CRAIG MILAM
KING RANCH SUBDIVISION
PO BOX 118
FRENCHTOWN, MT 59834

RE: Sanitary Survey- KING RANCH SUBDIVISION

PWSID#MT0004158

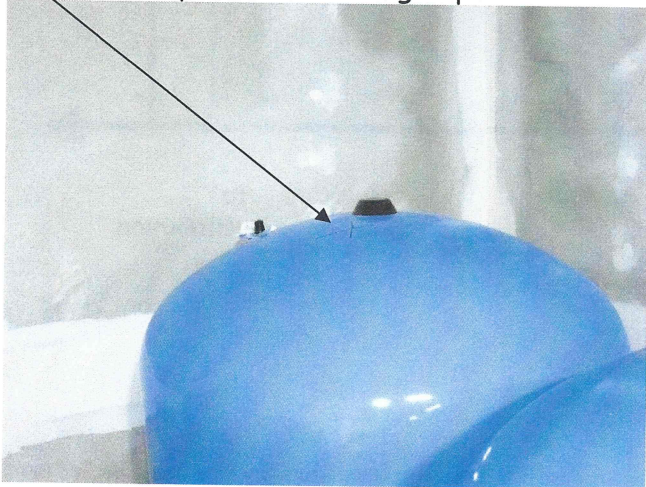
The pressure switches are set to lead/lag pressures of 40 - 60 and 38 - 65 psi.

The blow off is capped on the outside of the building.

Note the "x" on these tanks showing that they're believed to be waterlogged. They were in the process of being replaced.

A fourth tank also has an "x" (see schematic).

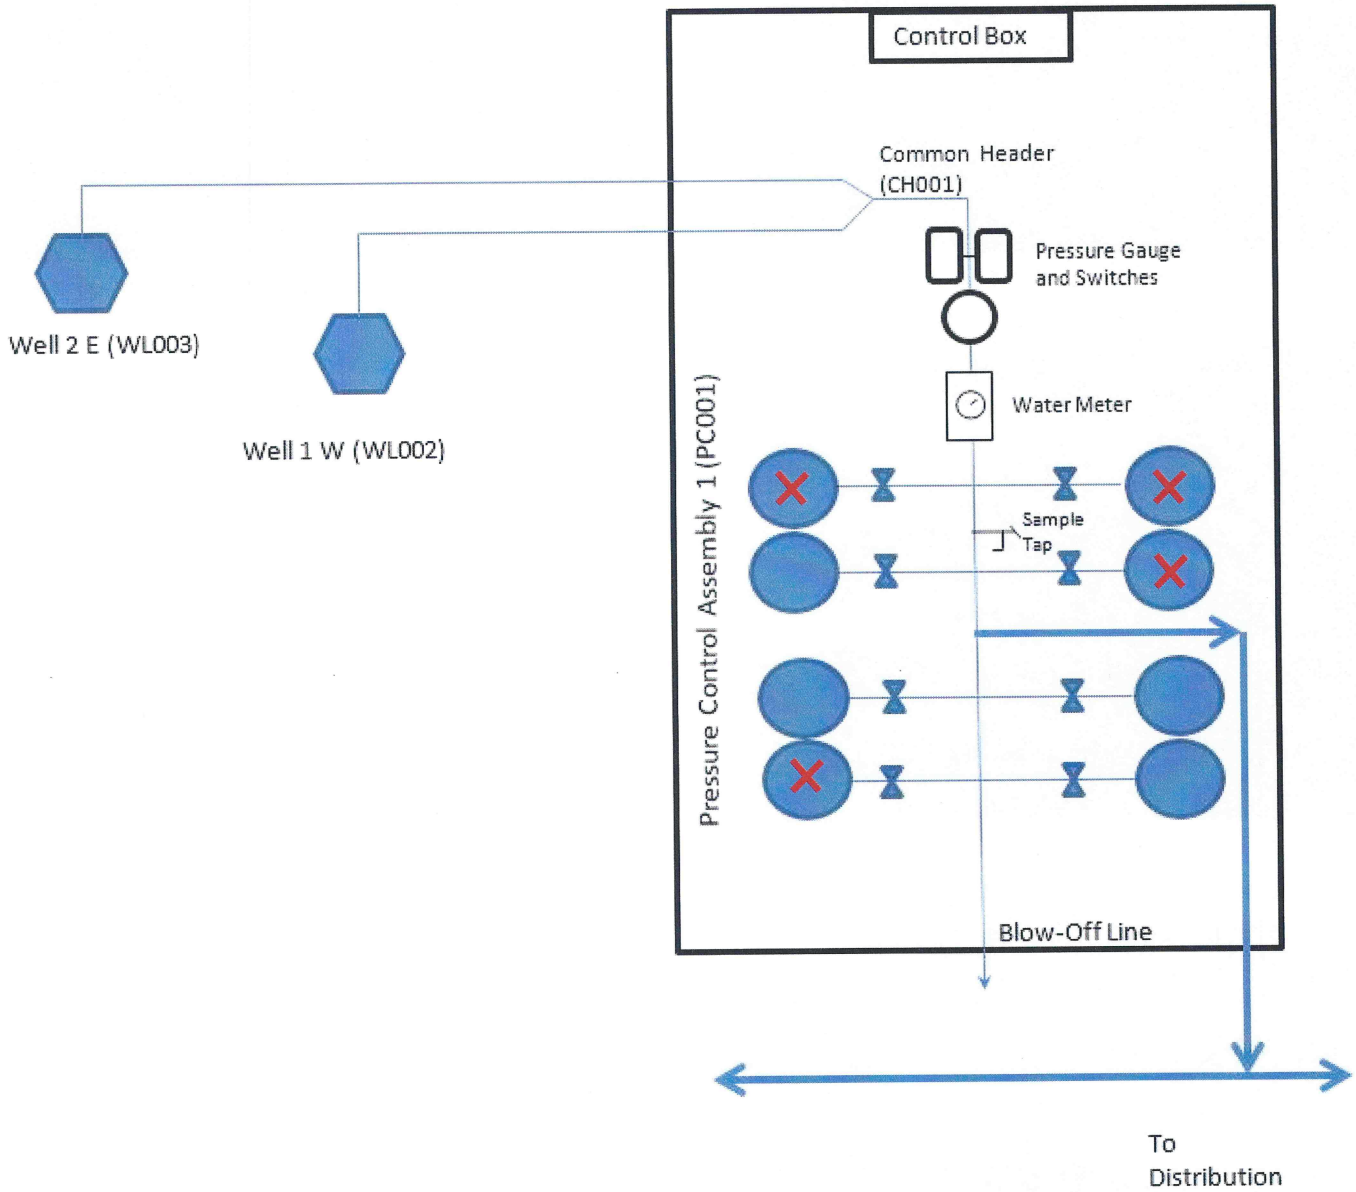
✗ Waterlogged tanks in the process of being replaced

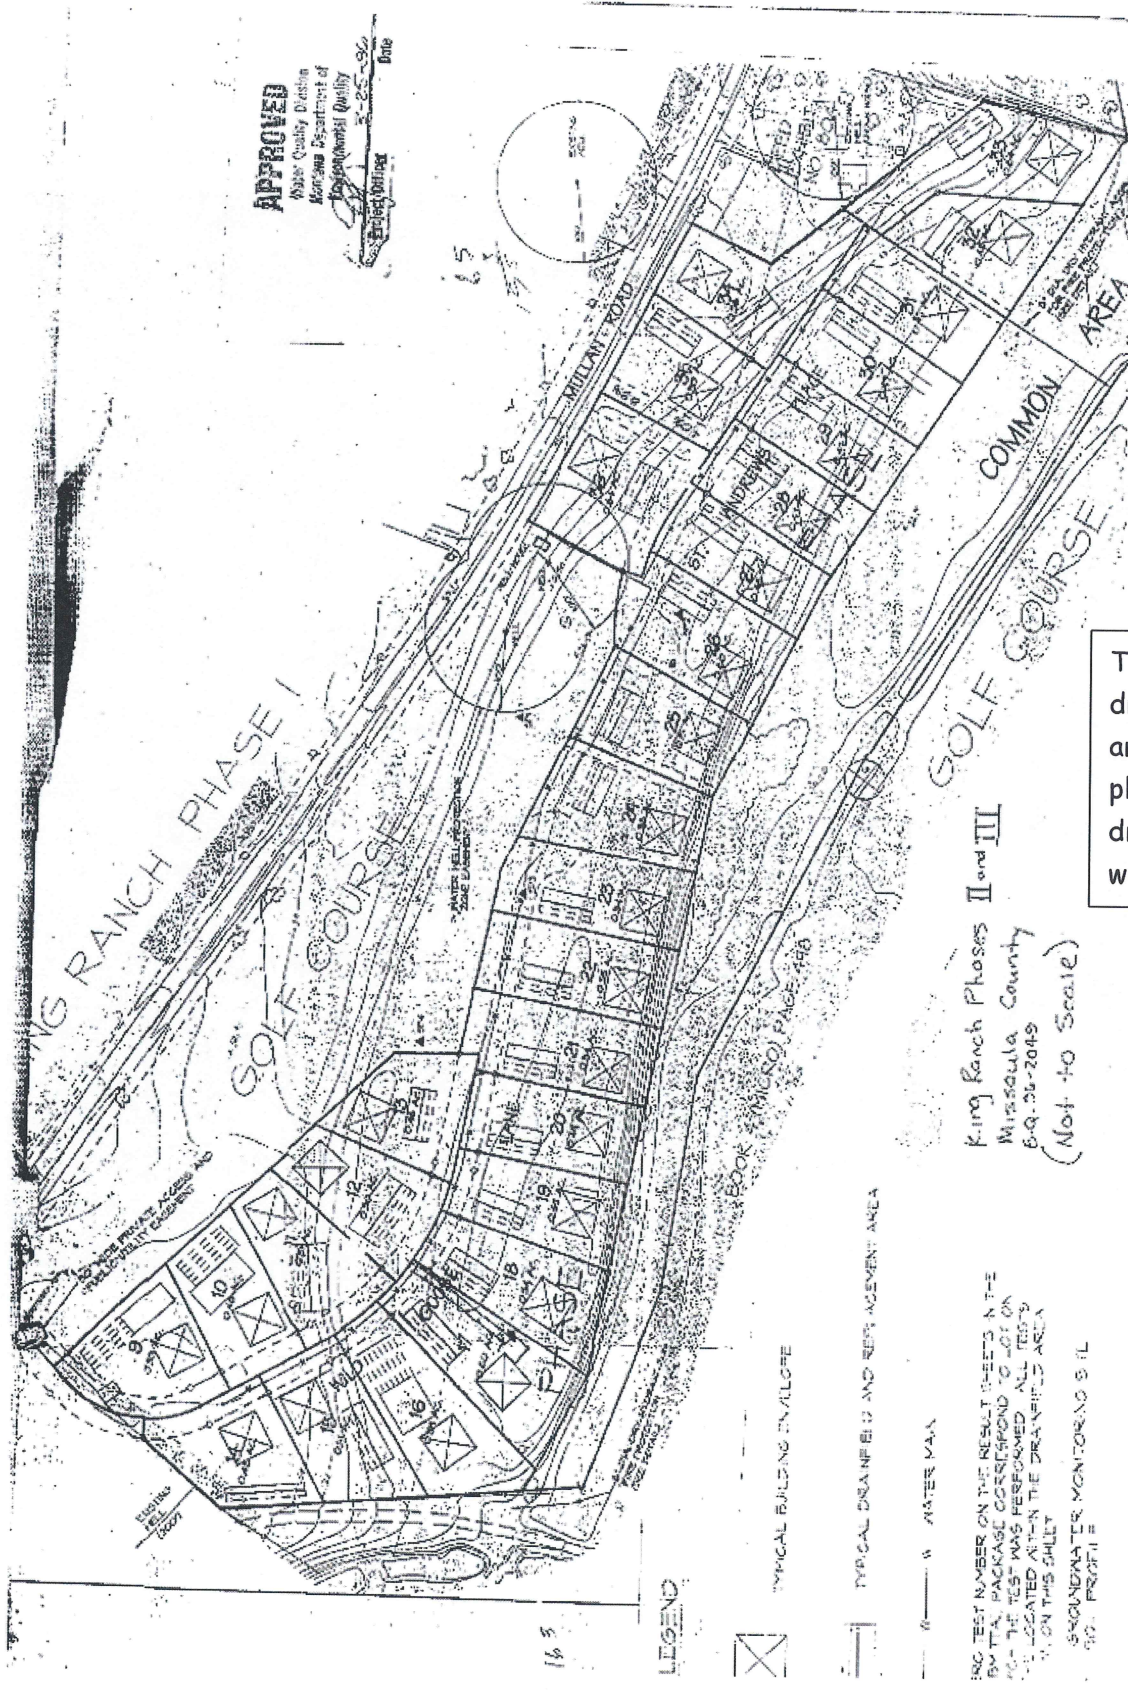
The wells were not drilled where they are shown on this plat map, but instead drilled a bit further west.
